**REQUEST FOR PRICE QUOTATION (RPQ)**

**RPQ ADDENDUM**

Addendum No:	4	Date	2/18/2026
RPQ No:	LB 7360: CO-RENO-25	Bid Due Date	3/10/2026
Project No:	CO-RENO-25	Project Title	Coconut Grove Branch Library Interior and Exterior Improvements
Project Location:	2875 McFarlane Road Miami, FL 33133	Project Manager	Shiham Colegial Lorenzo
Site Meeting Date:	1/28/2026	Site Meeting Time:	11:00 AM
Prebid Meeting Date:	1/21/2026	Prebid Meeting Time:	11:00 AM
Project Duration:	548 Days

Response Q107: Image

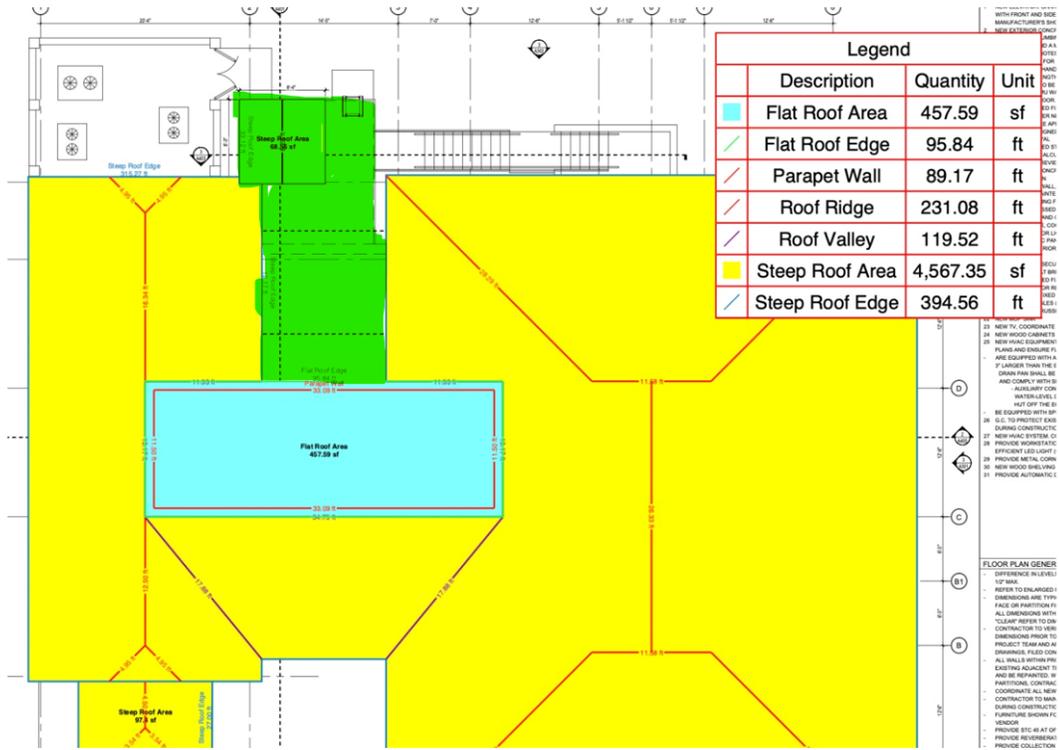
Q107: Are we re-roofing the entire existing roof (both the pitched and flat sections)? There is a note indicating that the shingle roof shall remain, which creates some confusion on our end. Or are we only installing the roof system on the new flat structure shown in the picture? Please advise so we can proceed accordingly.

Response Q107: Existing roofing to remain. Only new roof scope is for the elevator and extension to the elevator structure. For reference see image below. Areas in green.
